FINAL PLAT

WICHITA HEIGHTS HIGH SCHOOL ADDITION

RE: SUB 2002-69 -- One-Step Final Plat of Wichita Heights High School Addition

STAFF REPORT
(ONE-STEP FINAL PLAT APPROVED 7/18/02)

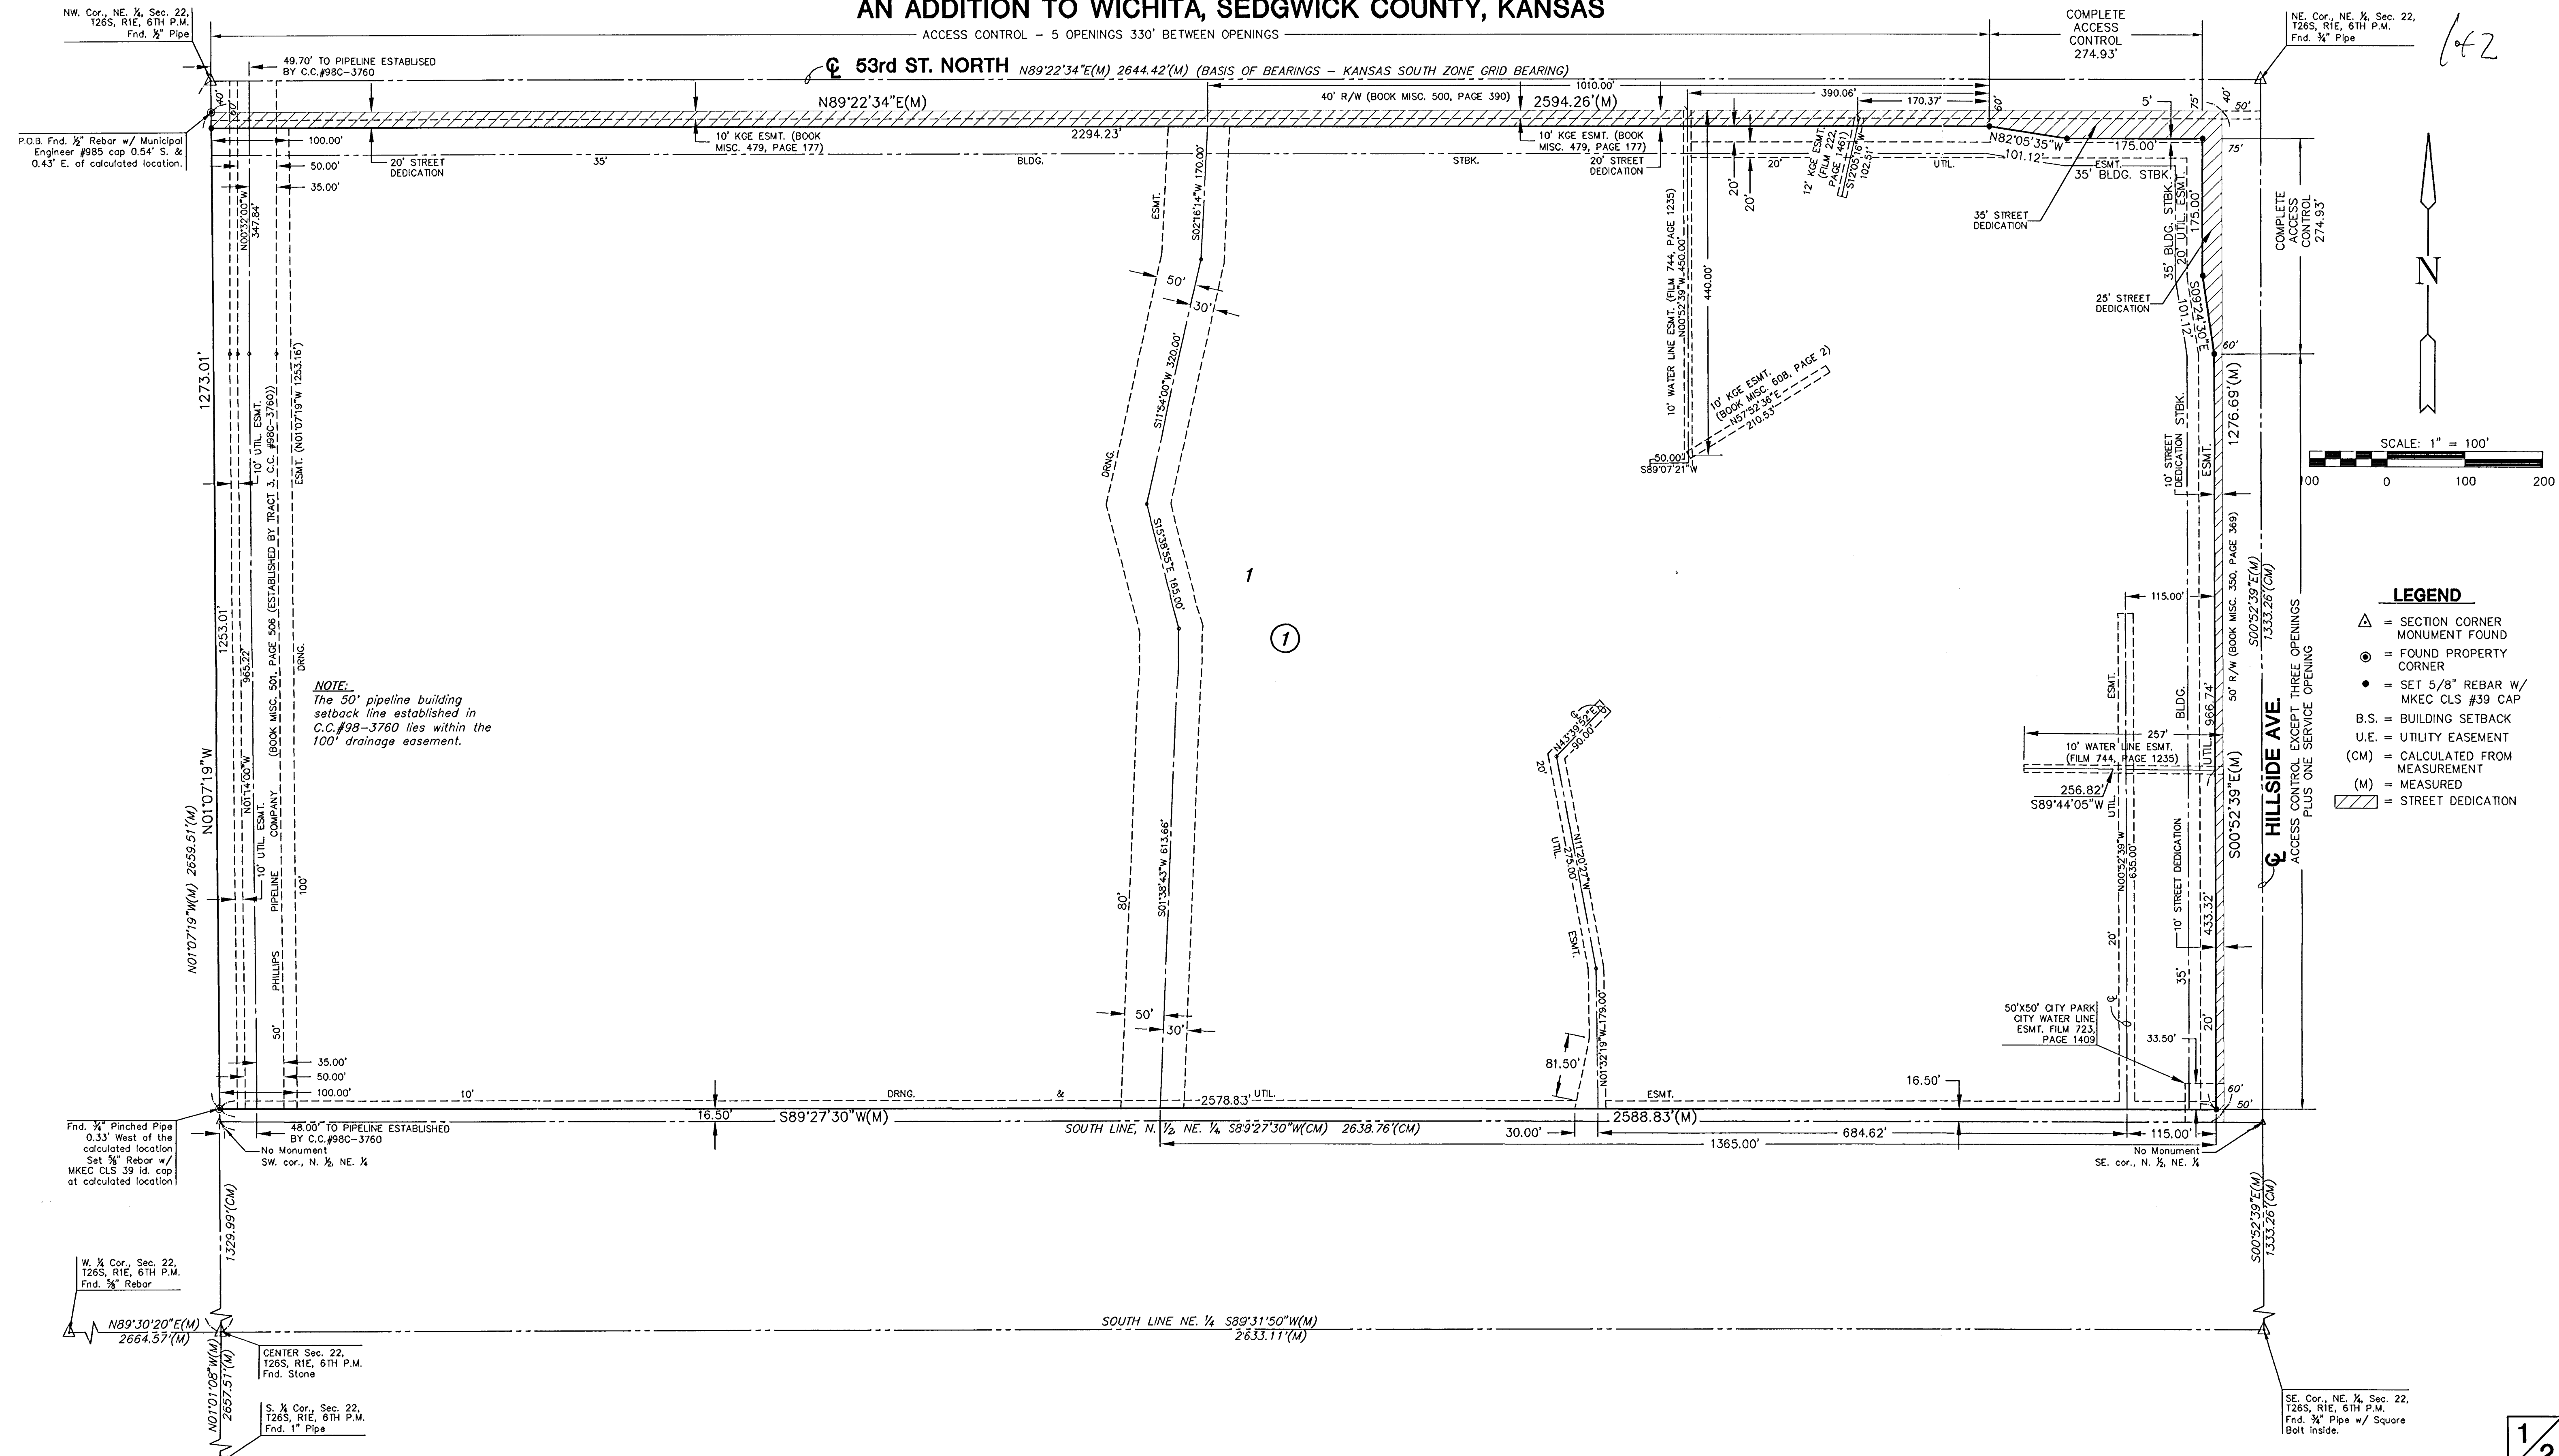
ACCESS CONTROL - 5 OPENINGS 330' BETWEEN OPENINGS

- D. Four openings (which includes one service opening) shall be permitted along Hillside. 660 feet between openings is needed along 53rd St. North. *Revised (see weber memo)*

- C. City Engineering needs to comment on the status of the applicant's drainage plan. *A drainage easement or drainage reserve is requested. A drainage plan shall be provided to County Engineering for their review.*

- D. Traffic/County Engineering needs to comment on the access controls, particularly the need for minimum separation between openings. The plat proposes five access openings along both arterial streets. *Sedgwick County Public Works requests a meeting with the applicant concerning access controls. MAPD and Traffic Engineering recommend four openings (which includes one service opening) be permitted along Hillside. 660 feet between openings along 53rd St. is recommended.*

- E. The Applicant has provided a pipeline document which appears to indicate a required 50-ft setback from the pipeline located on the property. The applicant's agent shall determine if any setback requirements for the pipelines by researching the text of the pipeline agreements. If a setback from the pipeline easements is provided for in the pipeline easement agreements, it shall be indicated on the face of the plat.

- D. Four openings (which includes one service opening) shall be permitted along Hillside. 660 feet between openings is needed along 53rd St. North.
- E. The Applicant has provided a pipeline document which appears to indicate a required 50-ft setback from the pipeline located on the property. The applicant's agent shall determine if any setback requirements for the pipelines by researching the text of the pipeline agreements. If a setback from the pipeline easements is provided for in the pipeline easement agreements, it shall be indicated on the face of the plat.
